2019 ANNUAL PAVING CONTRACT SPECIFICATION CHANGES

2019 Asphalt Regional Seminars

Rob Crandol - CO Materials Division

SP211: AC Variability Bonus

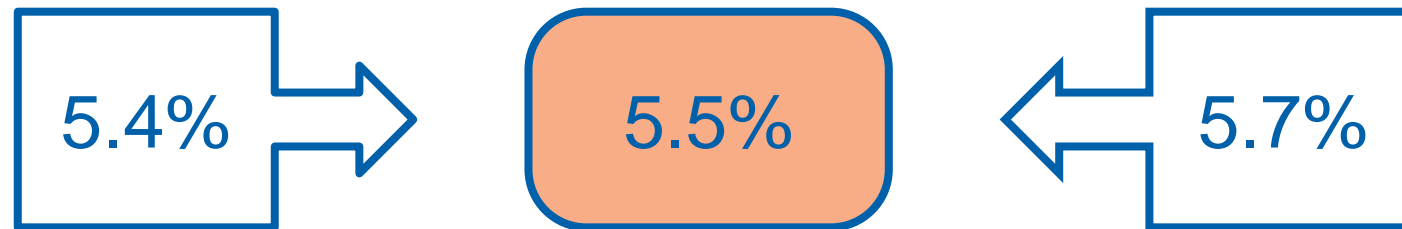
- AC Standard Deviation 0.0 – 0.15
- No Adjustments on Gradation (Table II-16)
- **Average Production AC** (additional requirement) should be,
 - No less than 0.1% below MD AC%
 - No more than 0.2% above MD AC%
